MEMPHIS AND SHELBY COUNTY OFFICE OF PLANNING AND DEVELOPMENT

STAFF REPORT

CASE NUMBER:S.E. 13-03

REQUEST: Special Exception to permit development of the property to exceed the maximum street frontage requirement of 100 linear feet in Paragraph 7.2.2.D.3 of the Unified Development Code for new development in the South Main Zoning District

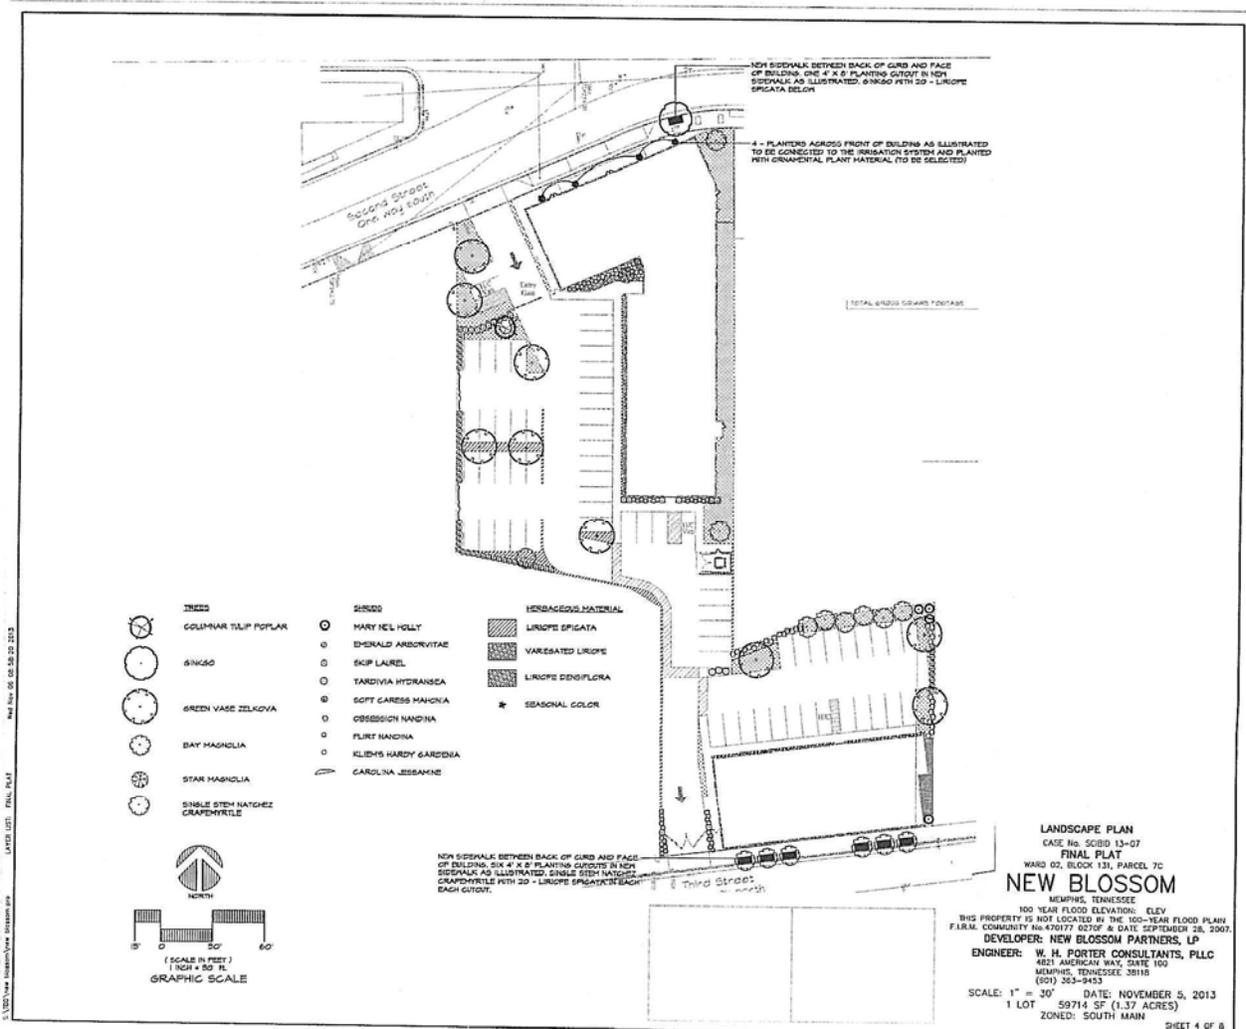
The proposed development plan is illustrated. A total of 64 apartments will be provided including 1,642 square feet of ground floor office/retail space in Building 1 on South Second Street.

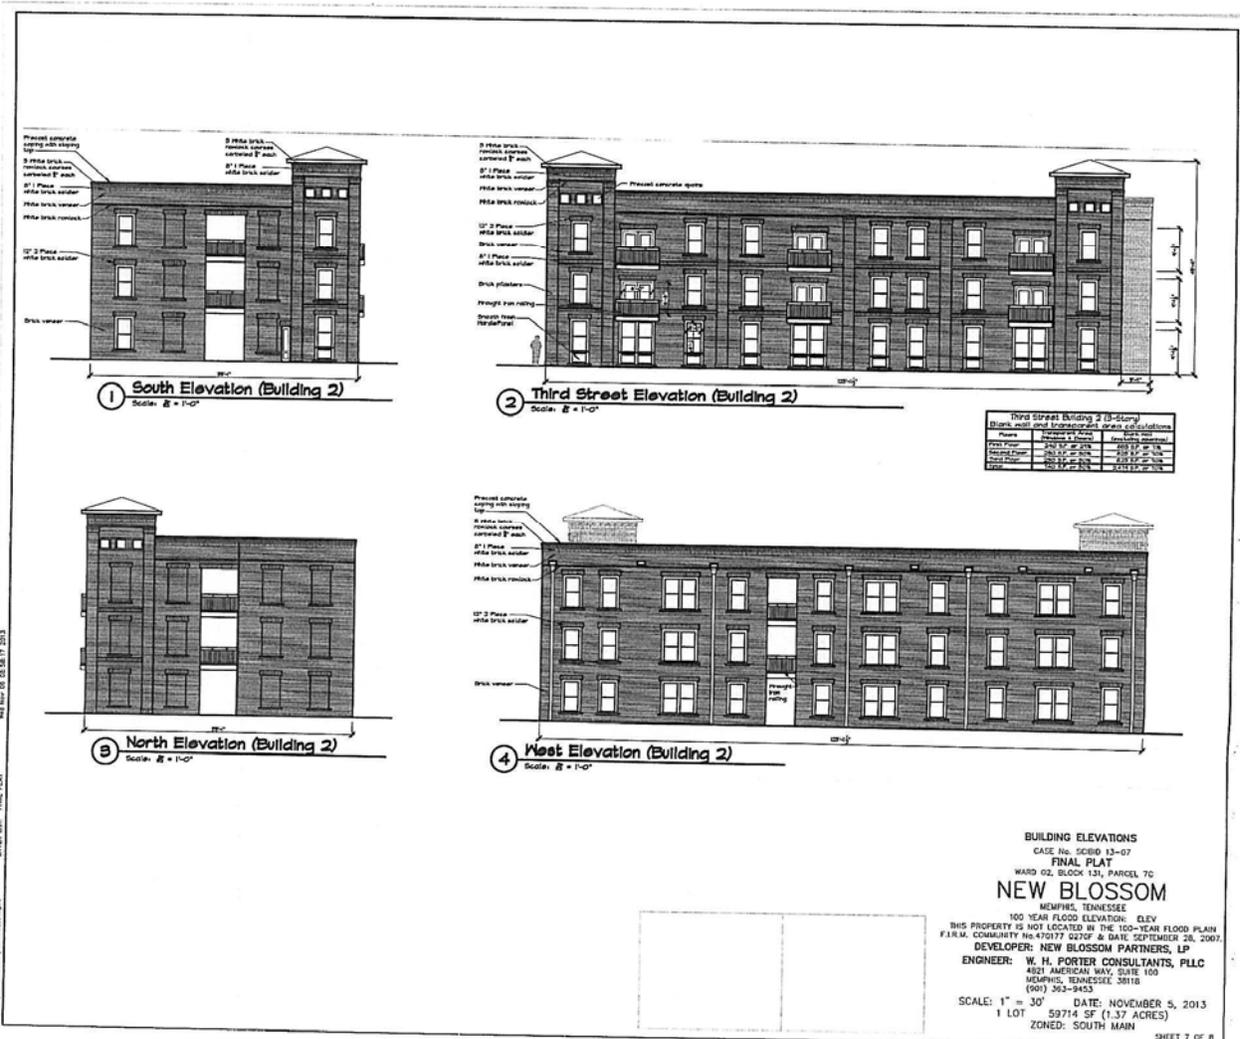
The South Third Street elevation includes pilasters, vertical end caps at each end of the building, wrought iron railing, and balconies to provide variety to the building façade.
